## PIERSON PARK REHABILITATION/ANDRE BROOK RESTORATION UPDATE

On September 6, 2011, the Village received bids for the Pierson Park Rehabilitation/Andre Brook Restoration Project. The project, which is primarily funded with grant monies from the New York State Department of State, as well as funding from the New York State Office of Parks, Recreation, and Historic Preservation; the United States Department of Agriculture, National Resources and Conservation Services and the Village of Tarrytown came in significantly over budget. Based upon the bids and the overall budget for the project, the Board of Trustees on October 3, 2011, rejected all five bids.

The Board of Trustees then tasked the Park Design Committee to work with the Design Consultants to analyze the projects and to make recommendations to the Board of Trustees on areas to reduce the cost of the project. The Design Committee, working with the Design Consultants, has made recommendations to the Board of Trustees on modifications to the project which will reduce the cost of the project. However, all of the components of the project remain. In some circumstances the reductions are in plant material and number of trees. In

- Approved plan for Pierson Park Rehabilitation. As noted, all of the components in the approved plan remain in the revised plan.
- 2 Pierson Park/Andre Brook Plan Modifications.

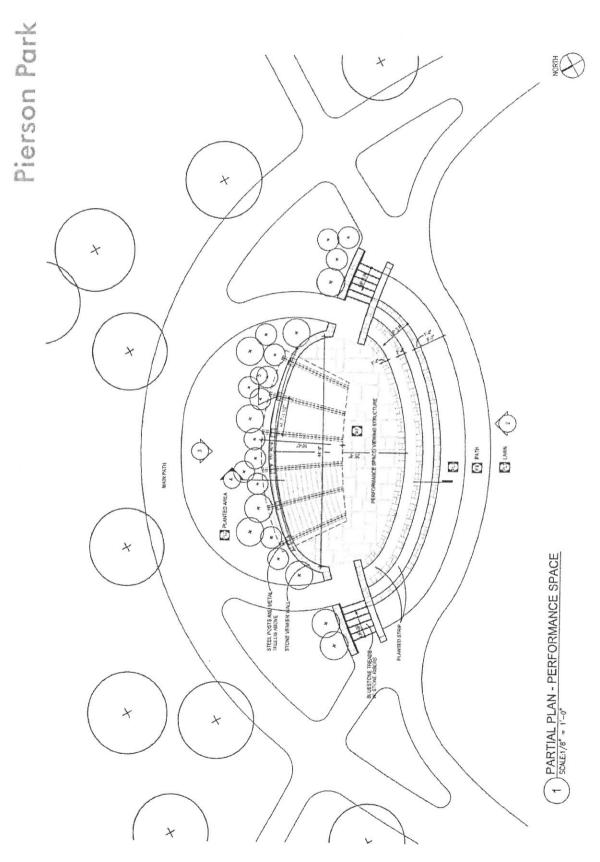
PIERSON PARK/ANDRE BROOK COST REDUCTIONS
PIERSON PARK - CHANGES TO PLAN
Redesign of Performance Space (structure and base)
No Thyme Planting at Performance Space
Reduce Size and Number of Trees
Reduce Quart Size Plants to 2" Plugs
Modify Curbing (Keep Existing Curb at South End of Parking Lot)
Eliminate 5 Islands at Parking Lot East of Andre Brook
Keep Existing Paving at South End of Parking Lot
Eliminate Natural Stone Boulders at Landform
Eliminate Bicycle Racks
Halve Number of Trash and Recycling Receptacles
Galvanized Handrail in lieu of blackened steel
Reduce Number of Benches by 4
Eliminate Green Street from Repaving Project in ParkingLlot
Redesign Picnic Shelter
Reduce Size of Fishing Pier
Redesign Lighting in Parking Lot

Pierson Park Performance Space Village of Tarrytown, NY

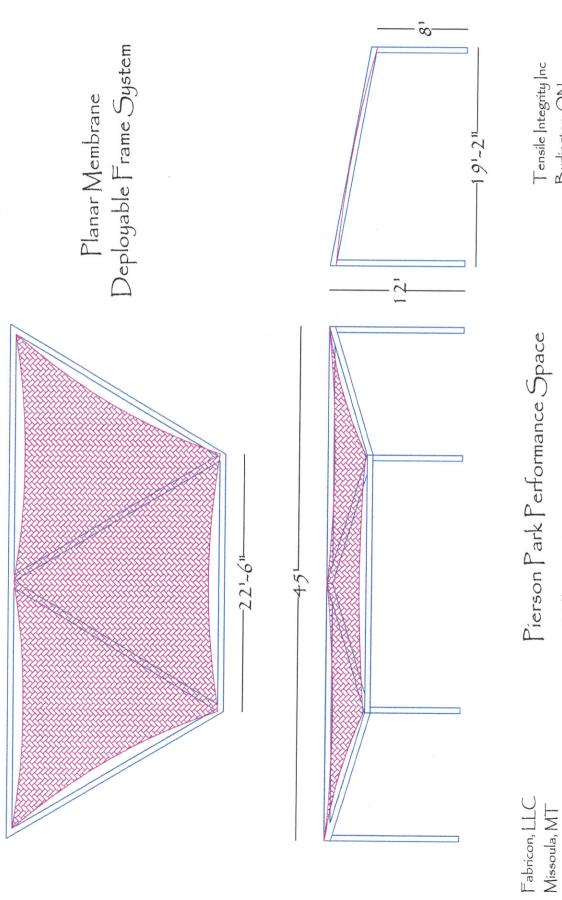
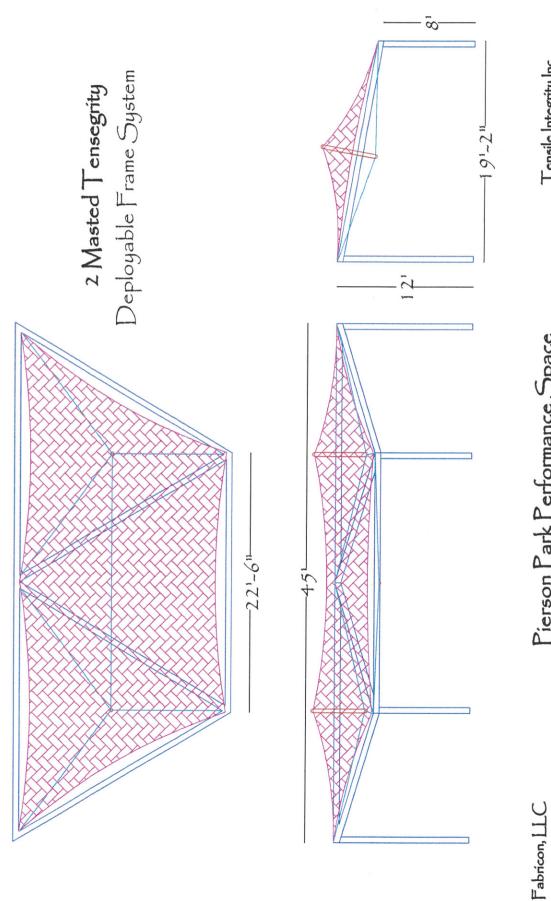
- 3, 4 Diagram of Performance Space from previous plan.
- 5, 6 New Performance Space Temporary Structure base of performance space to remain in original configuration. Performance space structure changed from permanent structure to temporary structure to be erected at beginning of season and removed at end of season.
